UNITED STATES
NUCLEAR REGULATORY COMMISSION
WASHINGTON, D. C. 20555

APPLICANT: Public Service Electric & Gas Company (PSE&G)
FACILITY: Hope Creek Generating Station
SUBJECT: SUMMARY OF STRUCTURAL AND GEOTECHNICAL ENGINEERING
BRANCH (SGEB) MEETING

On August 1, 1984, a meeting was held in the Bethesda, Maryland offices of the NRC to discuss the remaining SGEB-Structural audit open items identified in the Draft SER. A list of meeting attendees is included as Enclosure 1 to this meeting summary.

FIGURE A-13-26

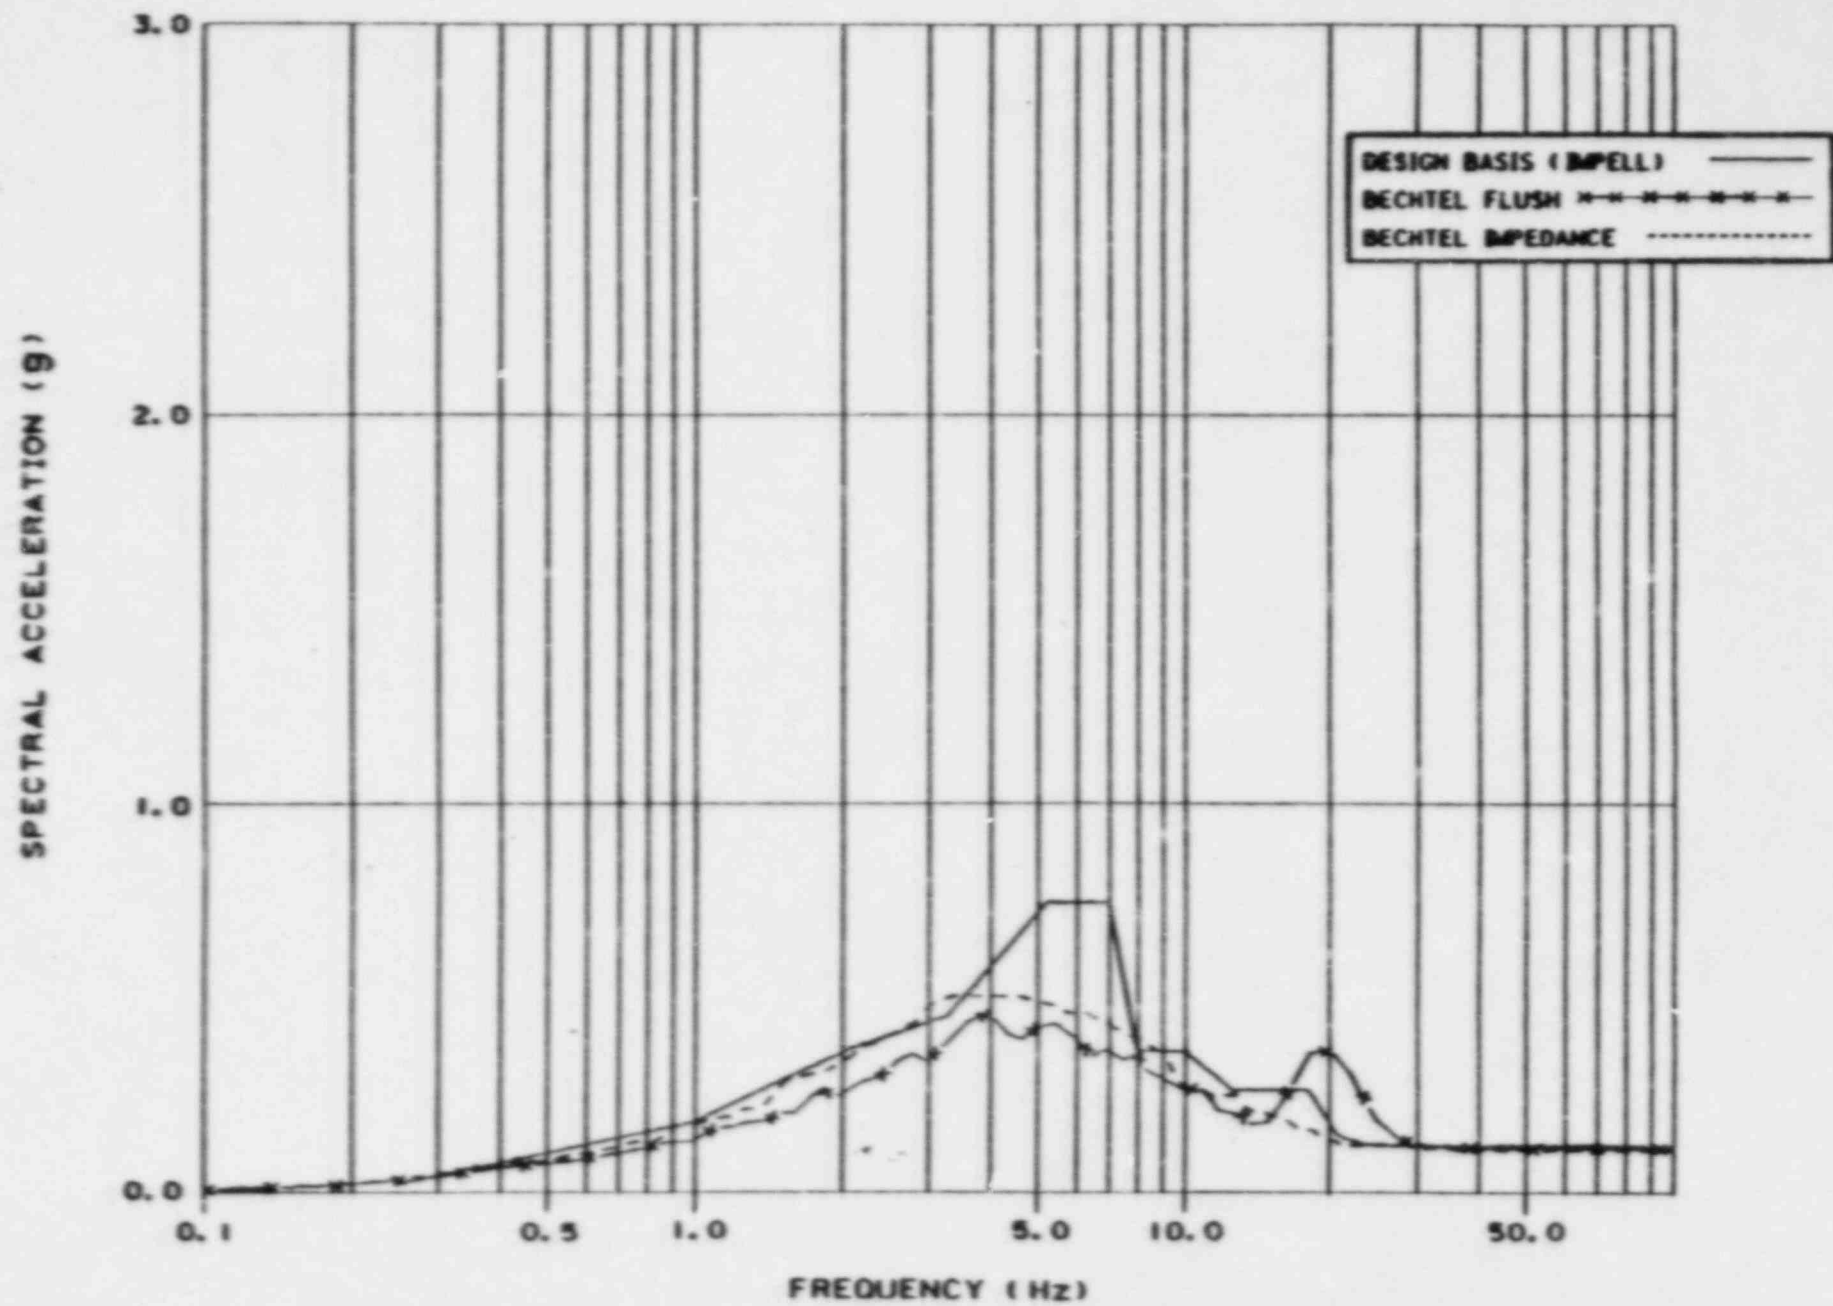
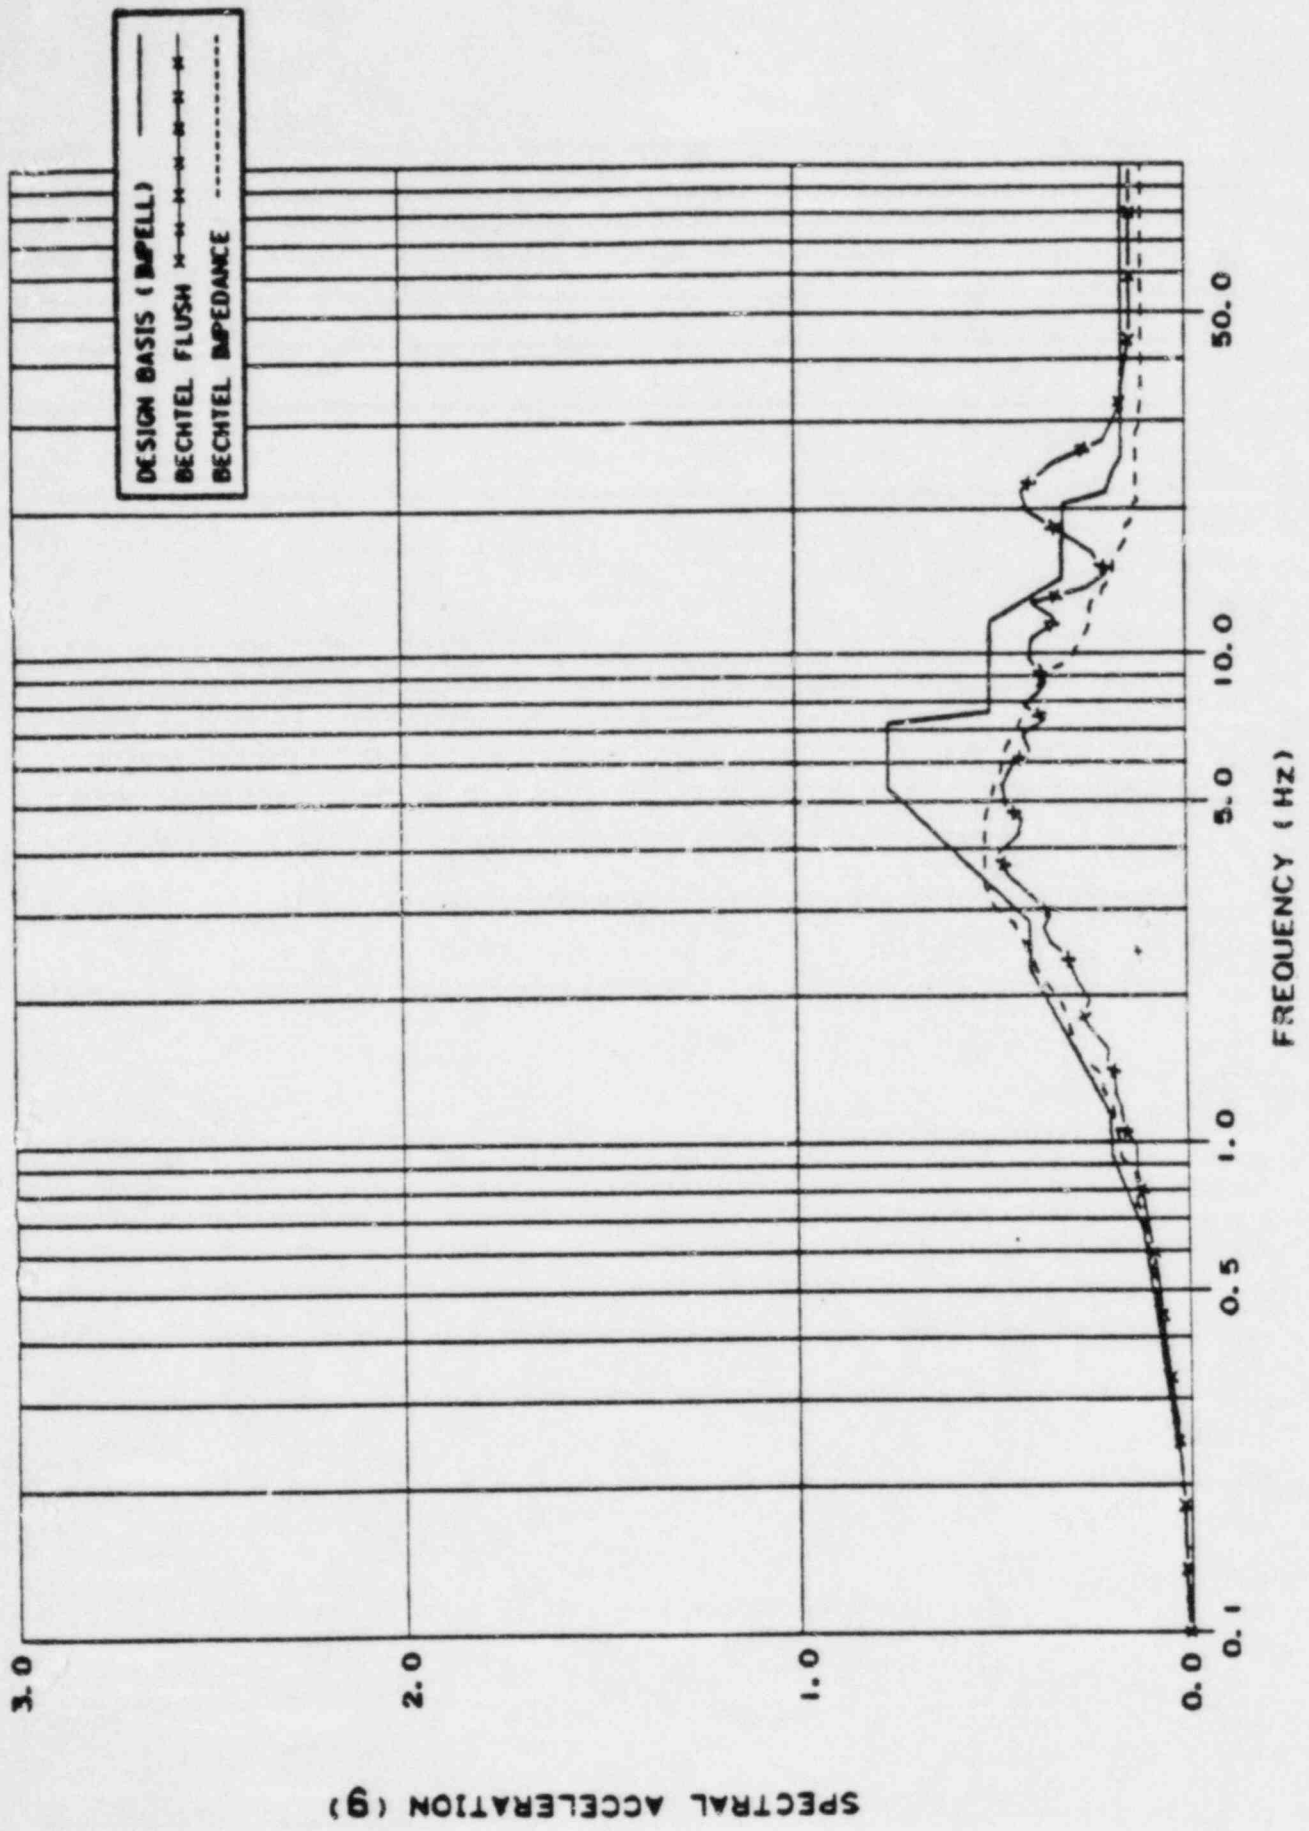
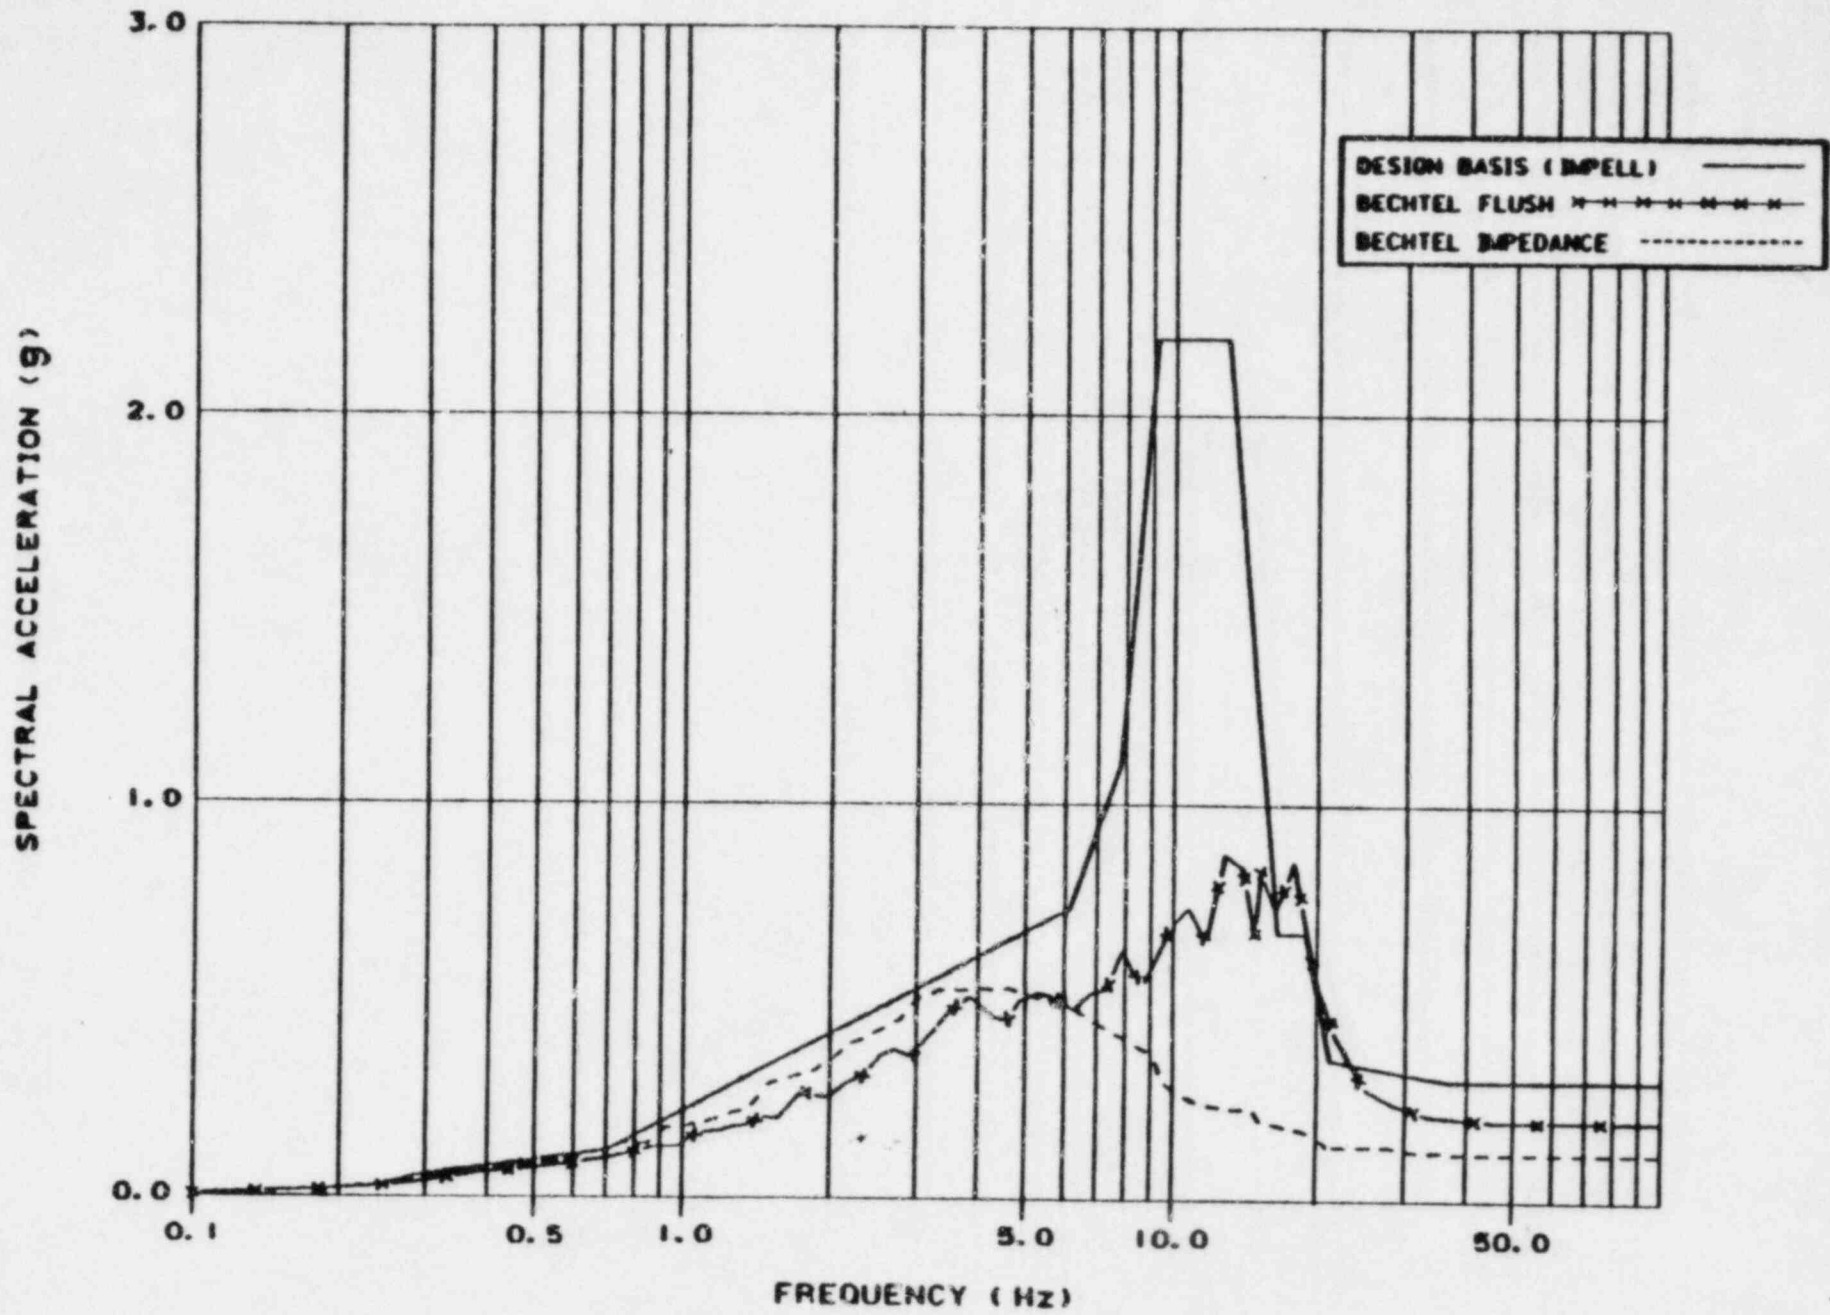
Question: Provide comparison of Bechtel Independent Verification Results with the Design Basis Results.

Figures A-13-2 to A-13-37 show the comparison of the response spectra (2% damping) obtained from the above three seismic soil-structure interaction analyses. Discussions of these comparisons are as follows:

Bechtel's independent soil-structure interaction analyses are performed using the computer code FLUSH. The results of independent finite element analyses are in reasonable agreement with those of the design basis analyses. As can be seen from Figures A-13-2 through A-13-37, the horizontal response spectra obtained from the independent finite element analyses are generally enveloped by those obtained from the design basis analyses except for the frequency range lower than 2 Hz. The vertical response spectra showed some exceedances at the frequency range of 18 Hz. These exceedances are listed in Table A-13-1.

The peak spectral accelerations obtained from the impedance approach analyses are generally lower than those obtained from the design basis analyses. However, these response spectra are not completely enveloped by those obtained from the design basis analysis, especially in the frequency range between 1.0 and 3.5 Hz. Also, there are some local exceedances in the higher frequency range, as shown in Figures A-13-2 through A-13-37.
